STAFF REPORT

COMPREHENSIVE SIGN PLAN AMENDMENT

APPLICATION CSPA C-052-02

SKYLINE SEVEN (SKYTECH)

Image 5: Options 1-A and 1-B locations.

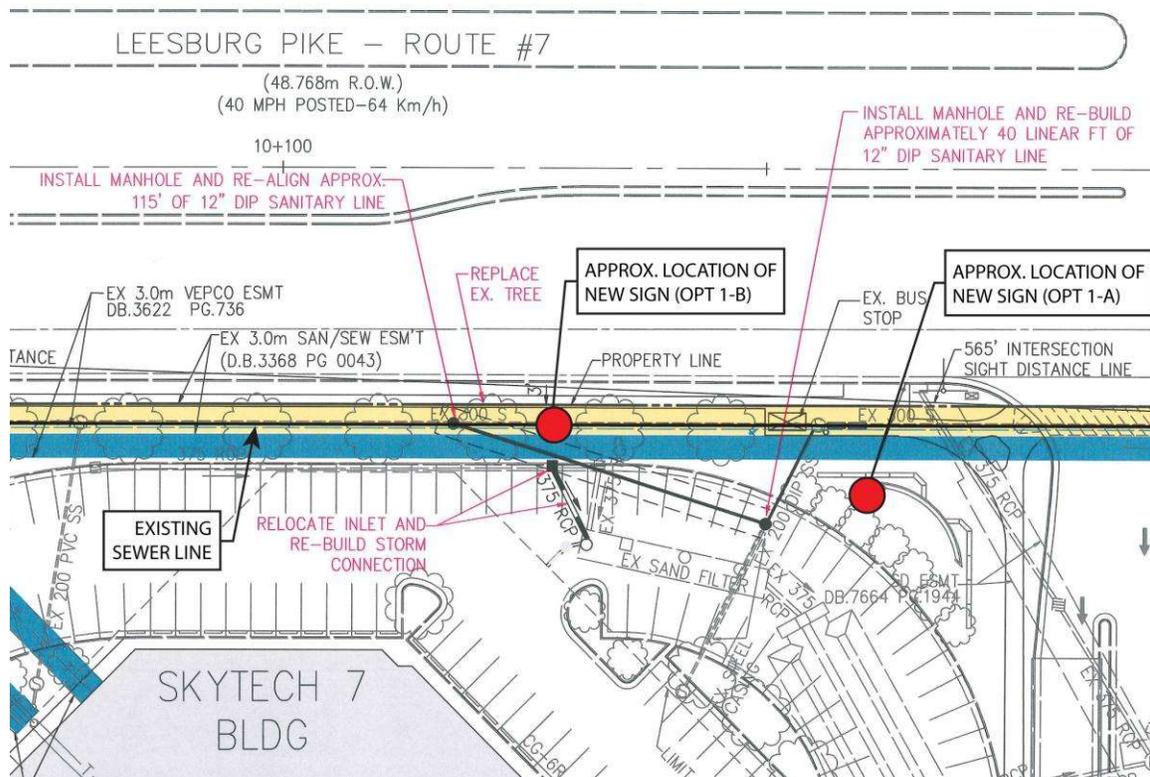
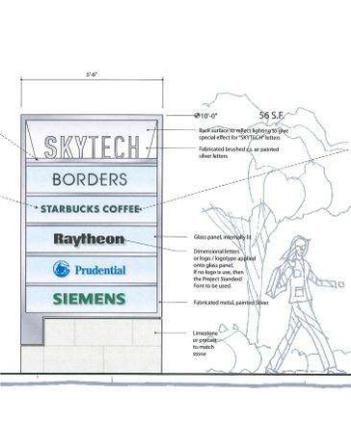
The applicant's preferred location for the proposed monument sign (shown as Option 1-B on the plan) would be just west of the entrance to the site, along the Route 7 frontage. This option would have the sign closer than the Ordinance-required 10 feet to the property line. In addition, a 10-foot wide County sewer easement is located directly adjacent to the existing sidewalk in this area that may not permit construction of a sign in this location, and there is a row of mature oak trees that may obstruct any sign placement along that frontage outside of the easement. The applicant would still like to pursue this location, despite the challenges, citing prominent retail signage as crucial to their ability to attract tenants to the building and make the project a success.

Since the applicant may need to relocate a segment of sewer line out of the frontage area, shown in the graphic, because of a proposed connection for a new restaurant in the building, the applicant may be permitted to place the proposed monument sign in this location. The required three foot clearance from the edge of the sidewalk will need to be maintained and the County Stormwater Planning Department will need to review and approve appropriate construction permits and modification of the existing easement (all of which are outside of the scope of this CSPA). This option would also involve extensive site disturbance, including removal of at least one mature oak tree and other previously-conditioned understory plantings. A development condition has been written to ensure that a replacement tree be located elsewhere on site and that understory plantings are restored.

The Urban Forestry Division of DPWES (UFMD) has concern with the possible removal of mature oak trees along Route 7 and/or the impact of disturbance on the critical root zones of those trees. For these reasons, UFMD staff does not recommend support of Options 1-B or 1-C for the location of the Monument ID Sign. A development condition was added to ensure the replacement of any tree lost with the selection of these options, elsewhere on site.

Staff's main concern remains the location of the proposed Monument ID sign, for which the applicant shows three location options on the CSPA. As discussed in the Analysis section of the report, staff favors location Option 1-A, although Option 1-B may be allowed if appropriate sewer department approvals are obtained, and if appropriate measures are taken to mitigate the impact to existing trees. Staff does not support Option 1-C for the Monument ID sign and has included a development condition to remove that option from consideration.

Proposed Directional ID Sign

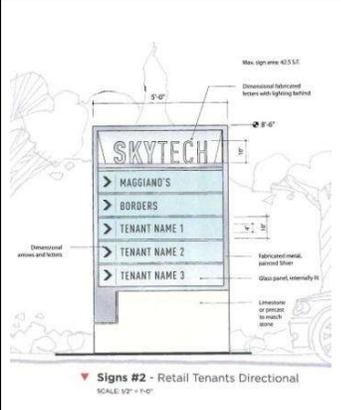
In addition to the main identification sign, there is a proposed secondary directional sign located just inside the main Skyline entrance and adjacent to the parking area of the Skytech building. This sign is also larger than the ordinance would allow but is similar in size and height to a “Directional Site Sign”, as specified in the original CSP, which served a similar function and was specified for this general location. Staff is comfortable with the size and location of the proposed Directional ID sign.

Proposed Ground-Level Tenant Signs

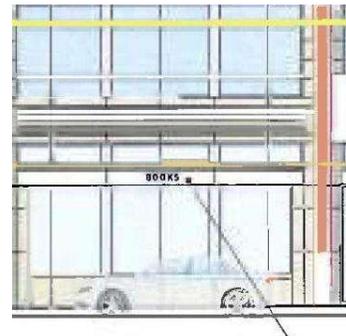
Ground-level tenants will have their own outside entrances, which will be identified by marquis-style overhead illuminated signs. In addition, each tenant may opt to include small “tagline” text on a metal band that runs the length of the frontage, just above window-height. Each tenant will be limited to a maximum size of 60 sf for both marquis signs and taglines, to be allocated at their discretion. The “by-right” signage maximum per tenant would be based on their respective frontage length. The proposed 60 sf per tenant is reasonable and staff has no objection to the proposal.

Proposed Blade Signs

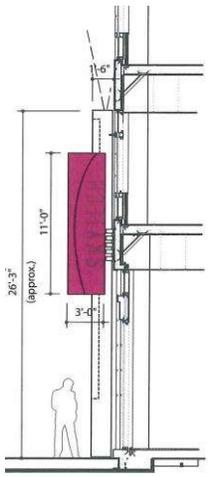
Vertical, illuminated “blade” signs will be utilized adjacent to each ground-floor tenant entrance, with a maximum of two per tenant, to provide an eye-catching appearance and to aid in pedestrian wayfinding. Other building columns not supporting blade signs will feature similar illuminated architectural accents, to create a distinct look and a vibrant street feel. This type of sign is not addressed in the ordinance but staff feels that, at a maximum of two per tenant, the blade signs are acceptable.
